Form MR-REV-att (DOGM – Revise/Amend Change Form)
 (Revised September 14, 2005)

Application for Mineral Mine Plan Revision or Amendment

Operator: Diamond K Gypsum	
Mine Name: Chalk Hills Quarry	File Number: M/015 /0095

Notice of Intention for the Chalk Hills Quarry

Diamond K Gypsum, Inc.	Emery County
Chalk Hills Quarry Permitting Base Map	Scale: 1" = 2,000'
Map Name: H:\2512-051\GIS\Projects\2512-051_Env\2512-051_Env.aprx - 1_Base_Map	1
Project Number: 2512-051	Last Edit: 04/06/2026
Drawn by: ALP 02-26

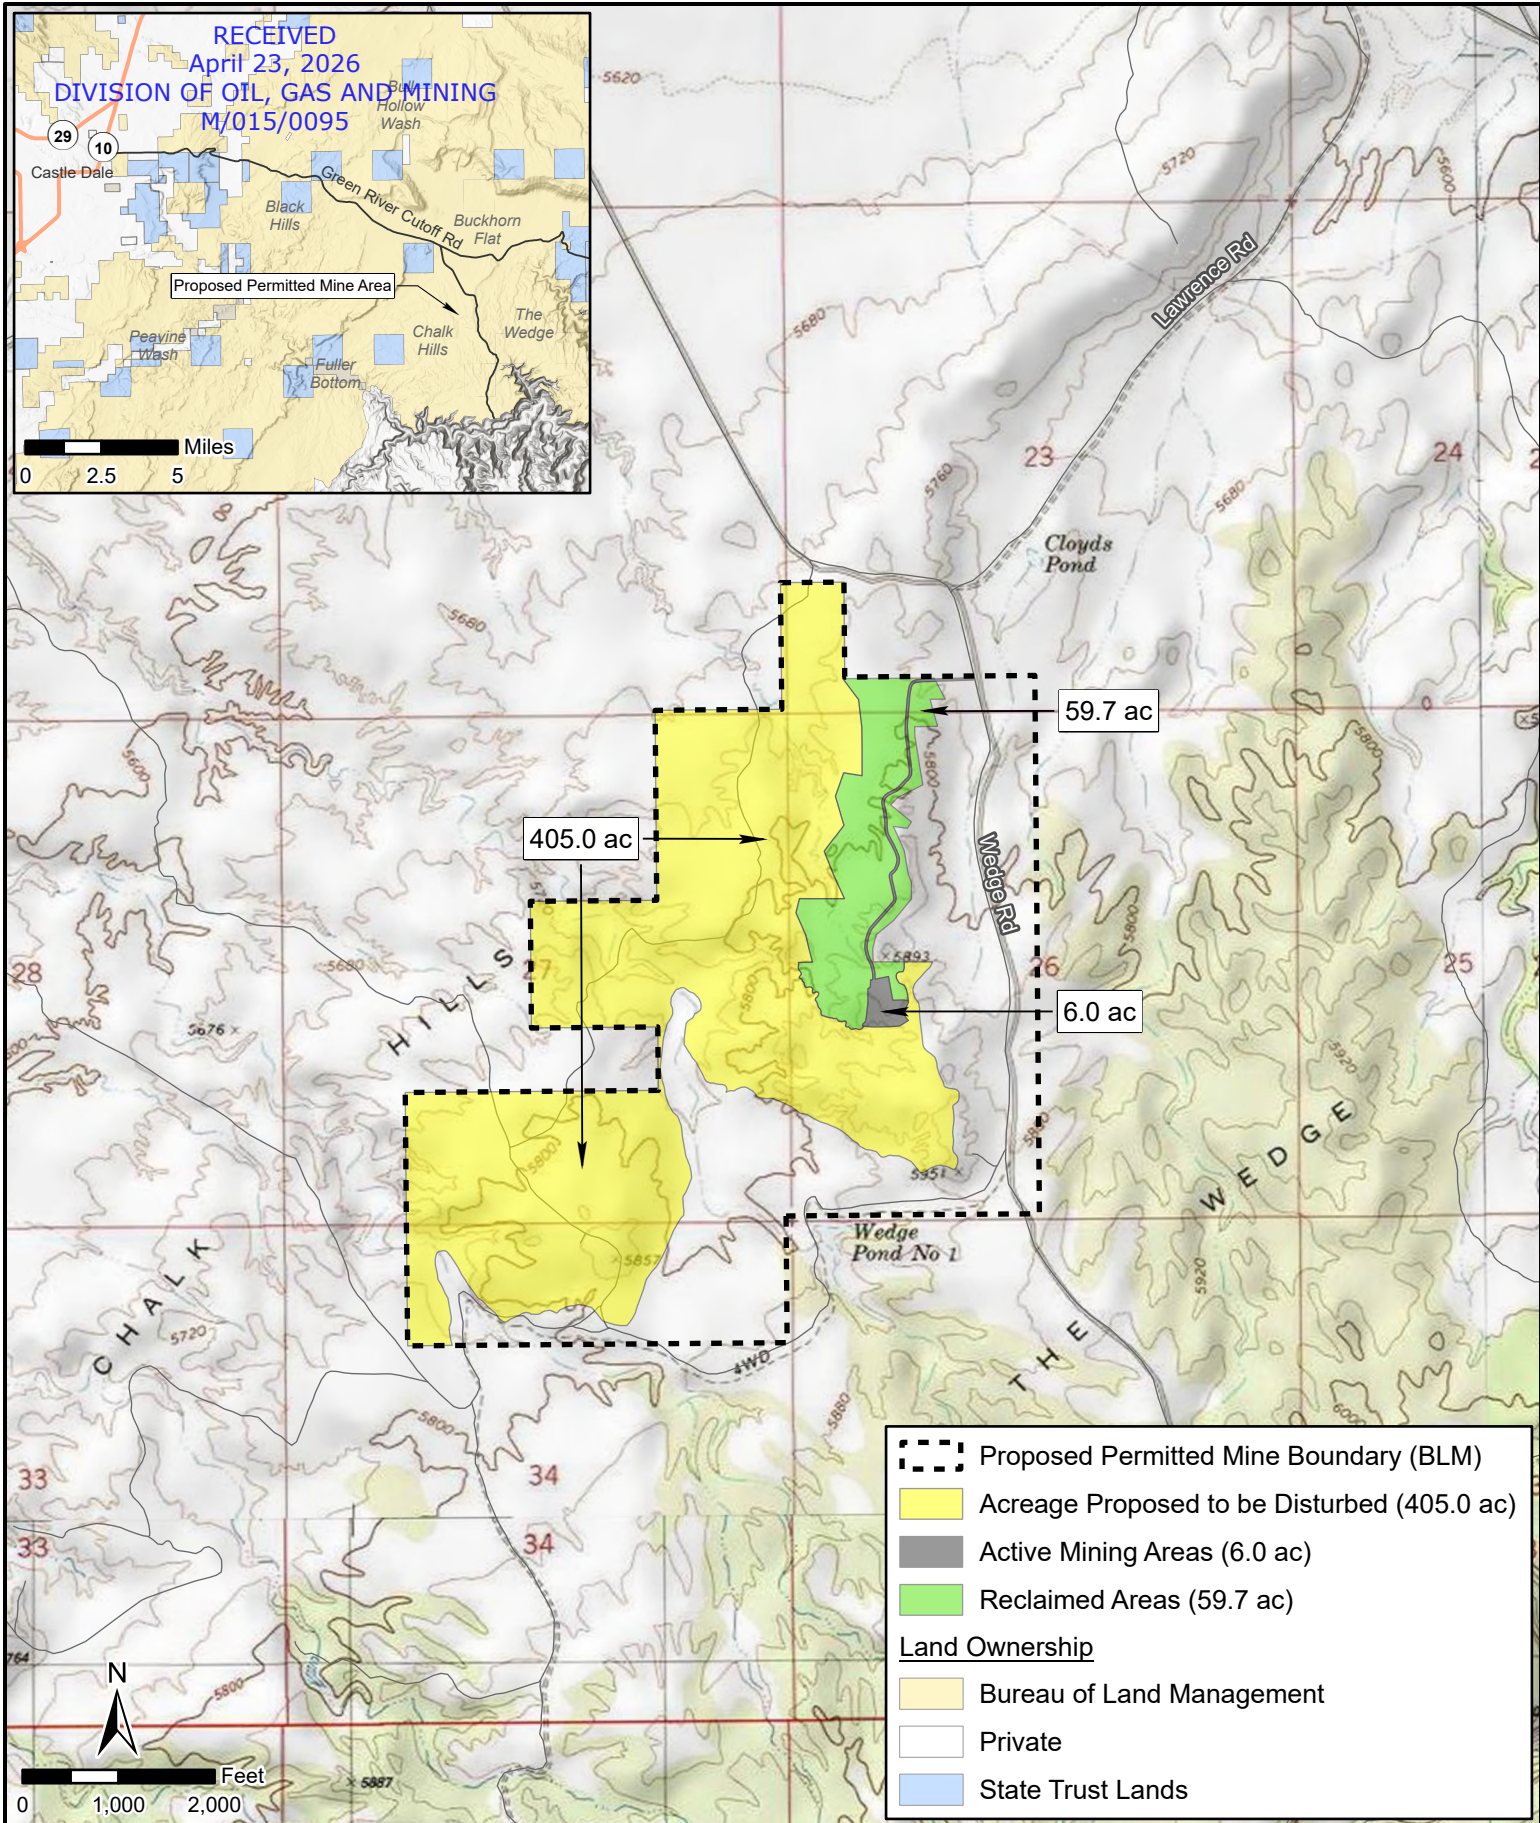
<input type="checkbox"/> ADD	<input checked="" type="checkbox"/> REPLACE	<input type="checkbox"/> REMOVE	Appendix A maps replaced
<input type="checkbox"/> ADD	<input checked="" type="checkbox"/> REPLACE	<input type="checkbox"/> REMOVE	Appendix D soil report replaced

Emery County, 30 miles northeast of Emery and 27 miles south-southwest of Price
T 19 S, R 10 E, Sections 23, 26, ~~and 27~~, and 34 (SLB&M).
See Map 1 in Attachment A.

Up to ~~160.5~~405 new acres could be mined in the permitted area (see Map 1 in Attachment A); the actual area mined will depend on the nature of the deposit and the topography of the site. The sequence of bonding and mining within the permit area will also depend on the nature of the deposit; estimated areas to ensure that disturbance remains within acreage limits are shown on Map 3 in Attachment A. This estimated sequence assumes mining of an average of 5 acres per year.

*Chalk Hills Quarry Permitting
Site Layout Map*

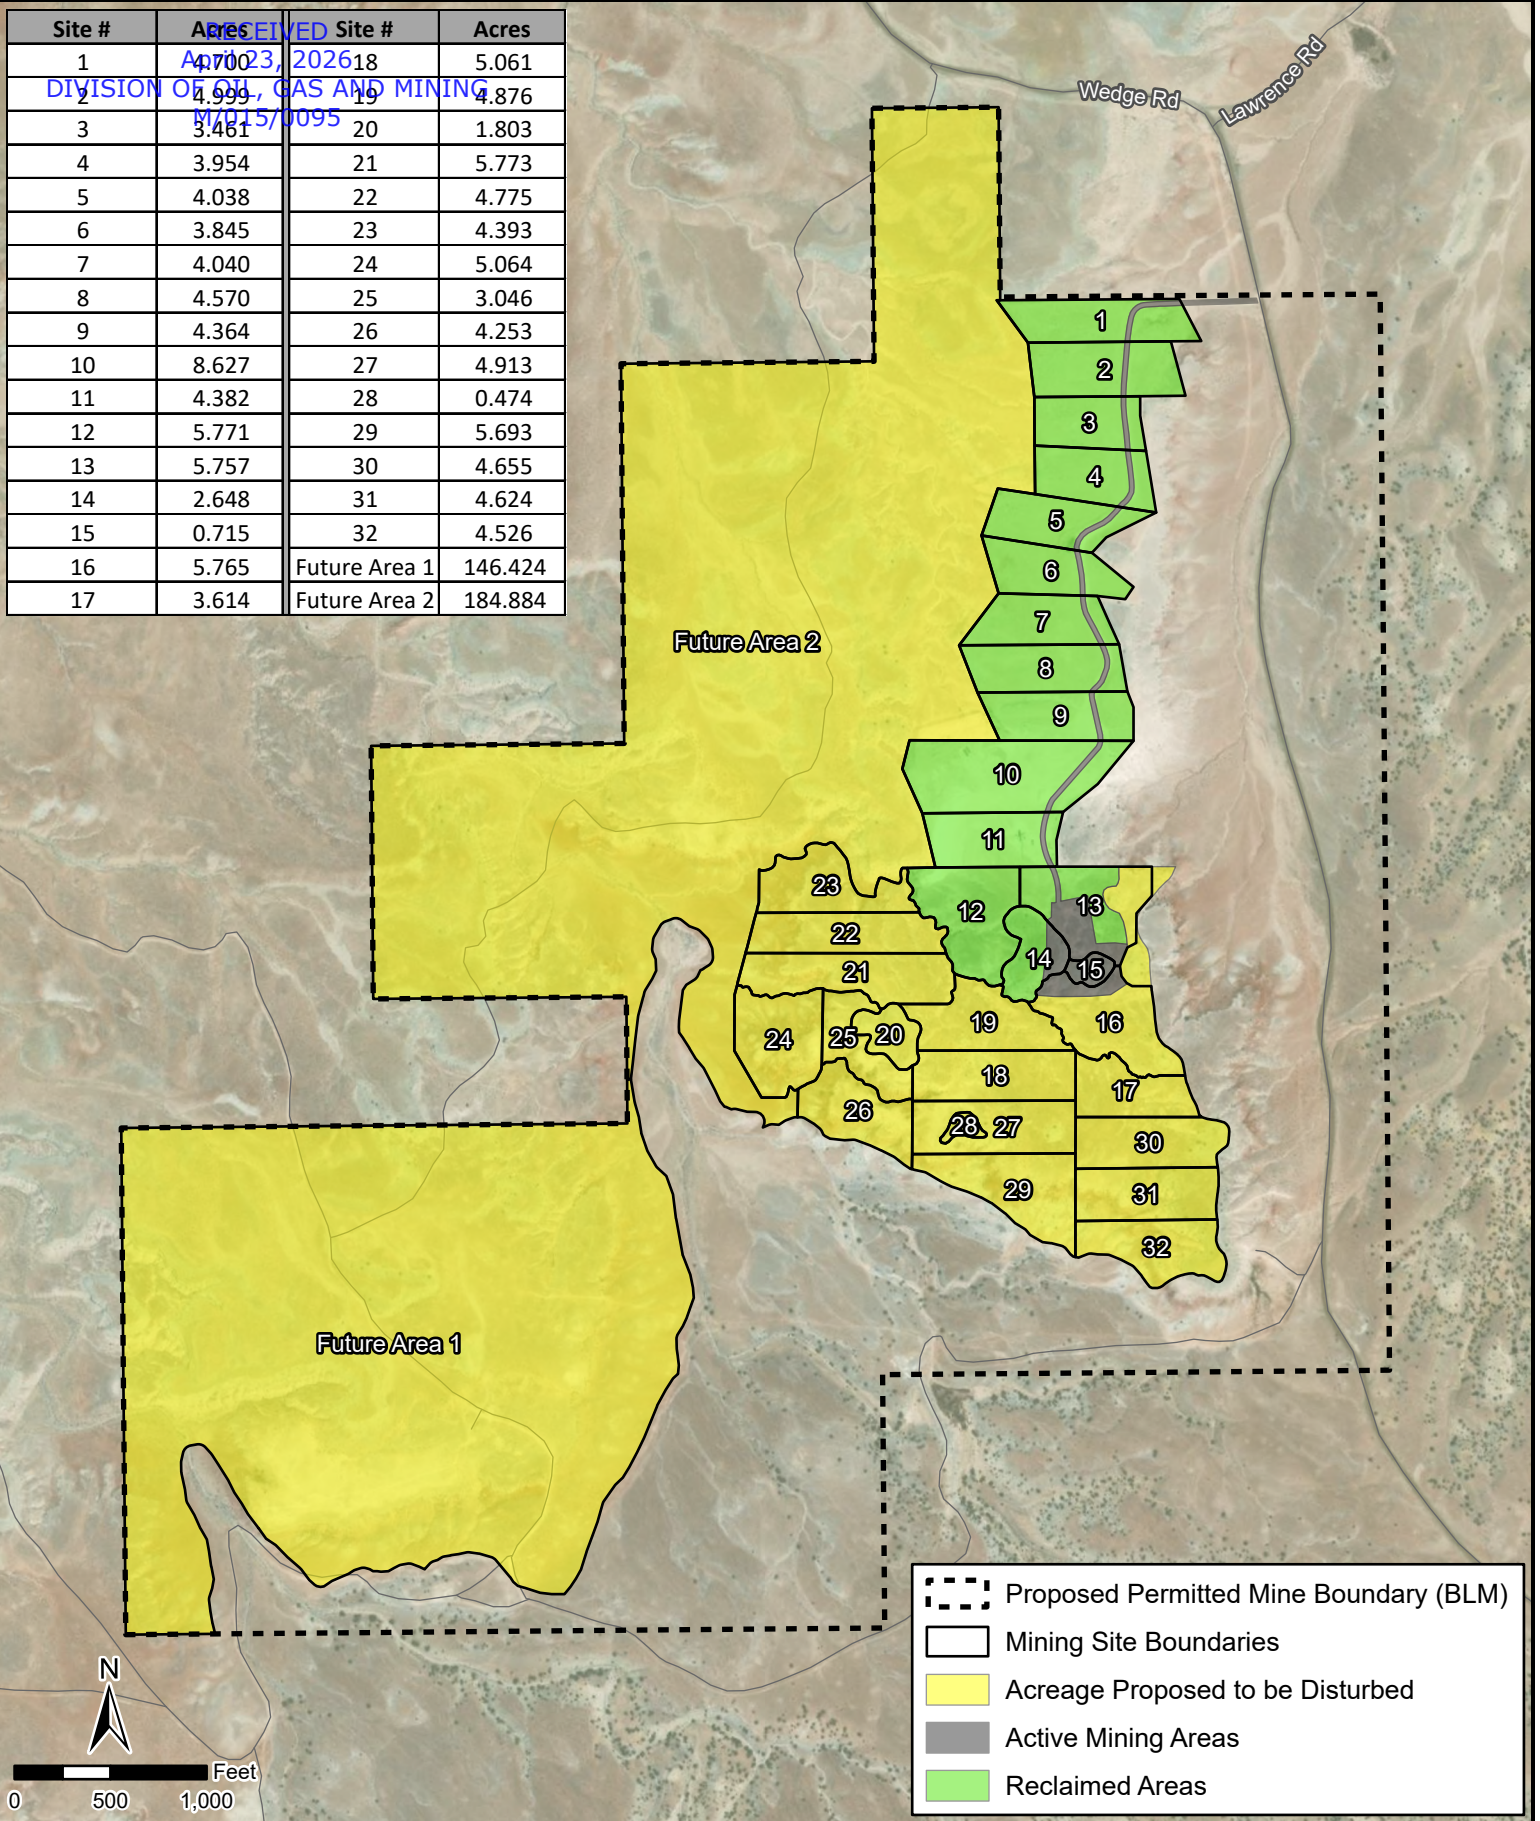
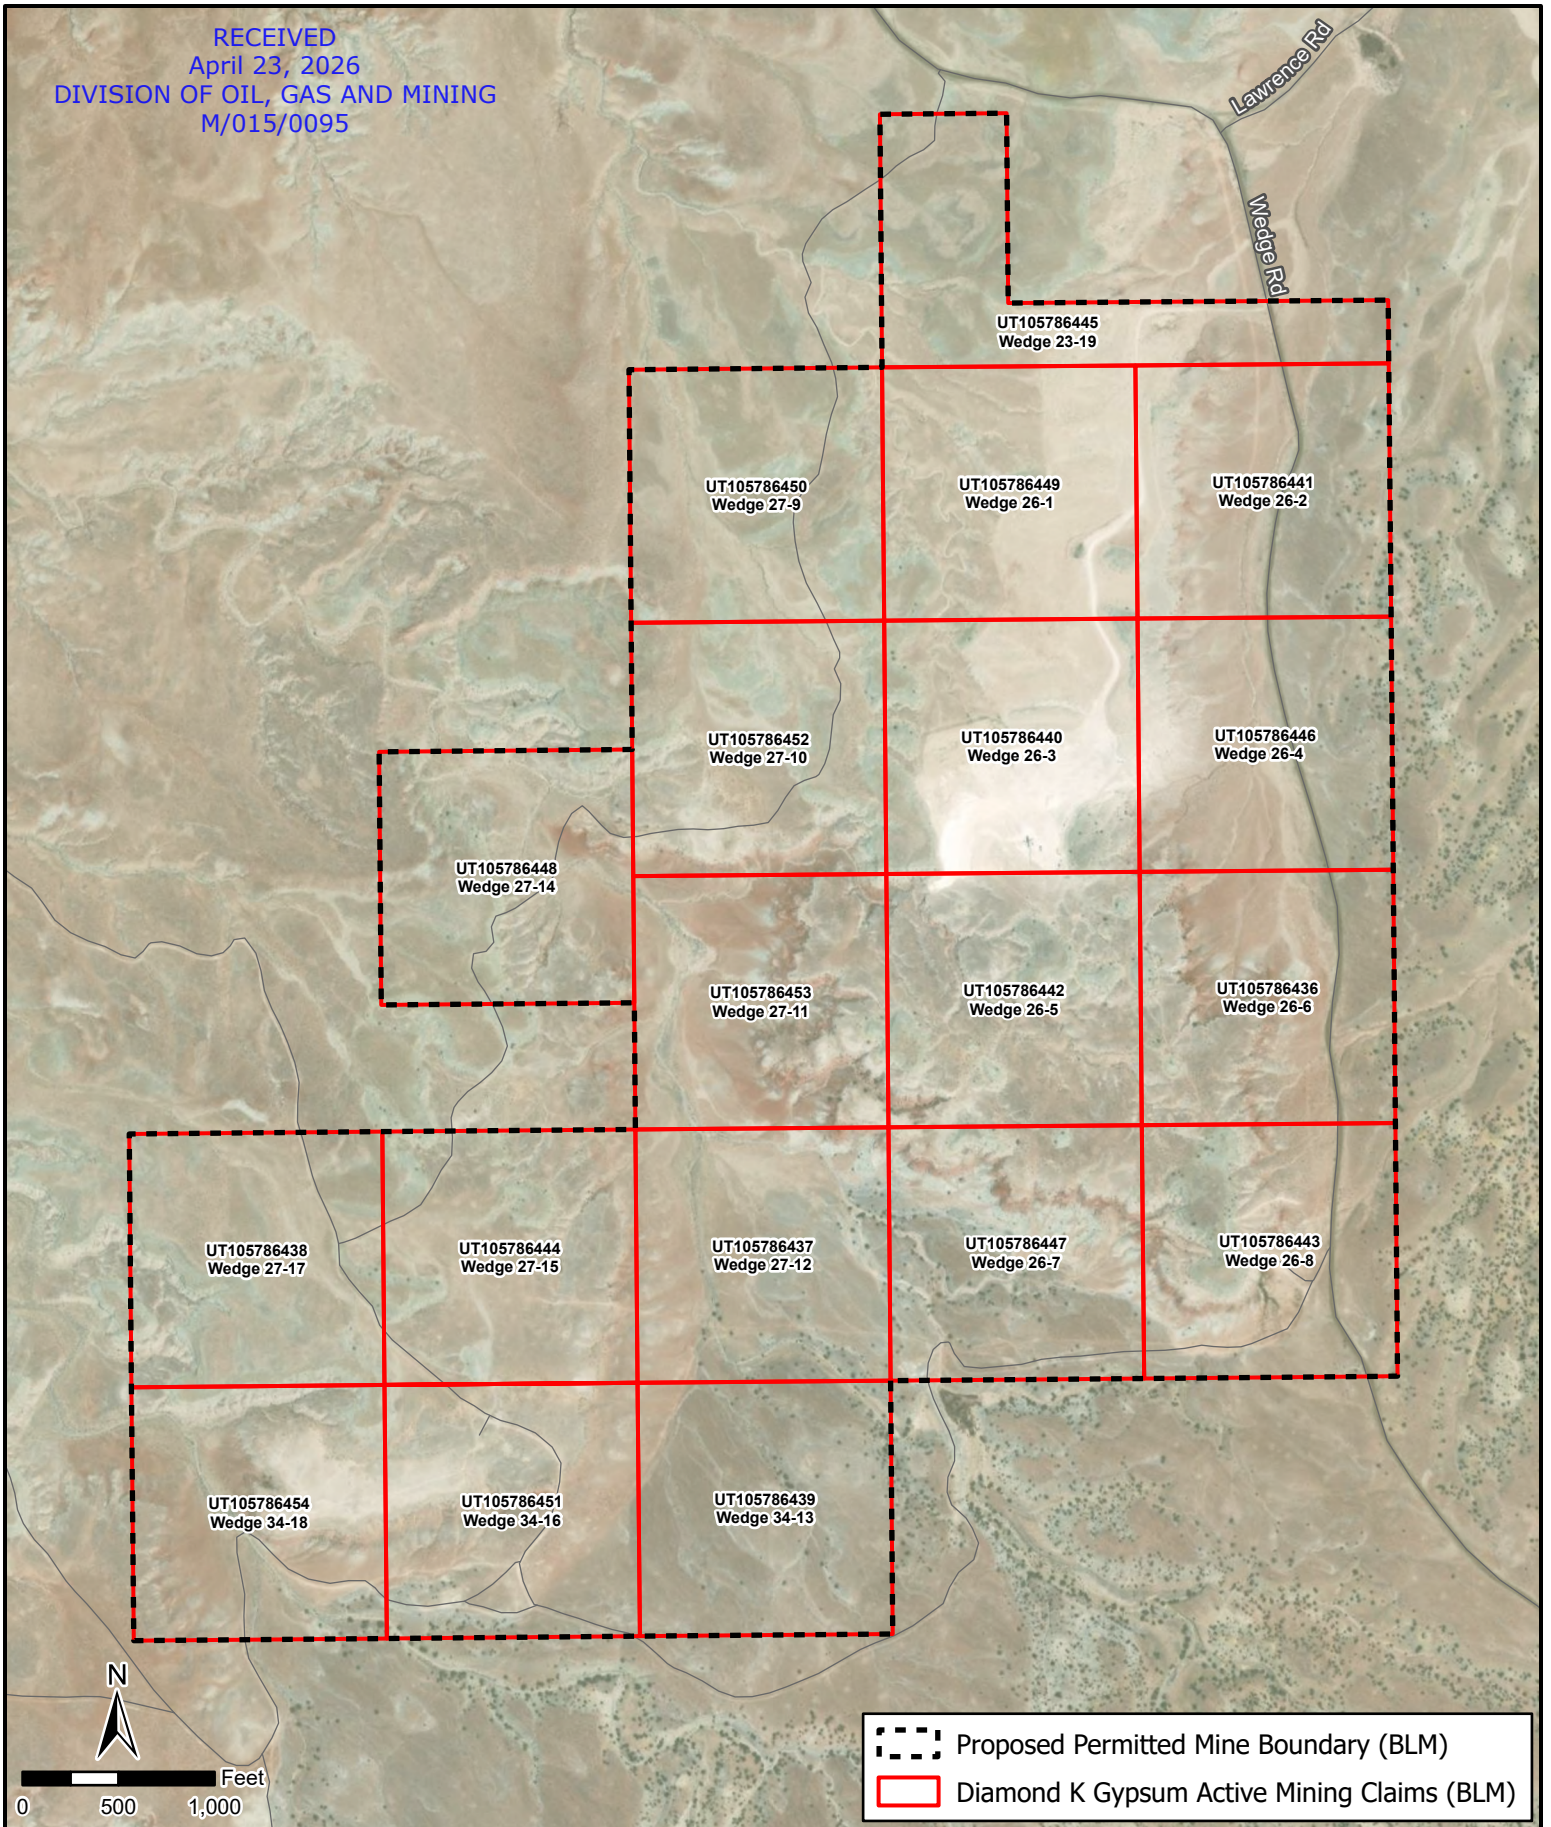
3. Site Layout Map: This map shows the anticipated sequence of areas to be mined, and includes details for areas that are currently mined or have been previously mined and reclaimed.
